CITY OF DALTON
CHANGE ORDER

AP023-9000-45(313) Whitfield

CONTRACT CHANGE ORDER NO.: 6 or SUPPLEMENTAL AGREEMENT NO.: -
 AIRPORT: Dalton Municipal Airport (DNN) DATE: October 13, 2025
 LOCATION: Dalton, GA GDOT IDENTIFIER PID: T008616
 CONTRACTOR: Integrated Builds, LLC Project: Hangar Development

**BACKING MATERIAL FOR ITEM 117 –
INSTALLATION OF OIL/WATER
SEPARATOR FOR 86' x 120' HANGAR
(SITE A)**

OIL SEPARATOR 1,000 GALLON CAPACITY

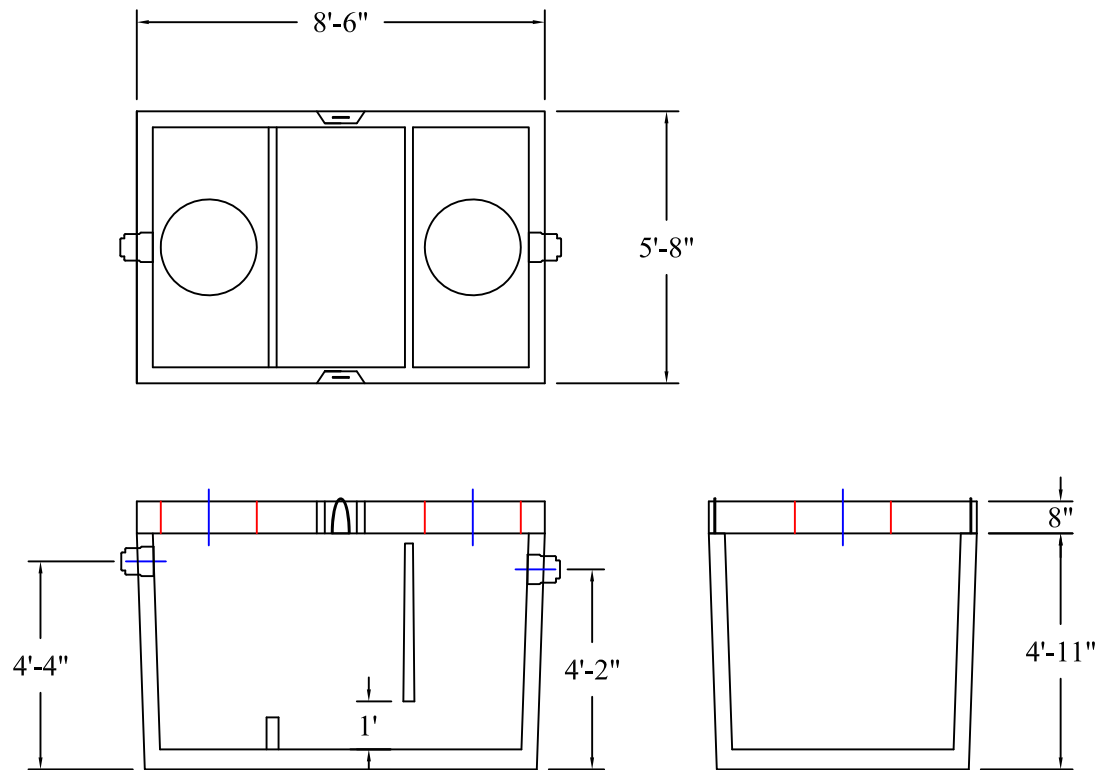
Contractor was requested to price and perform work required to install a 1,000 gallon capacity Oil/Water Separator to route effluent from the center trench drain inside the Site A Hangar Building to meet local building codes.

General Description of Change Order Request: Provide and install grease interceptor.
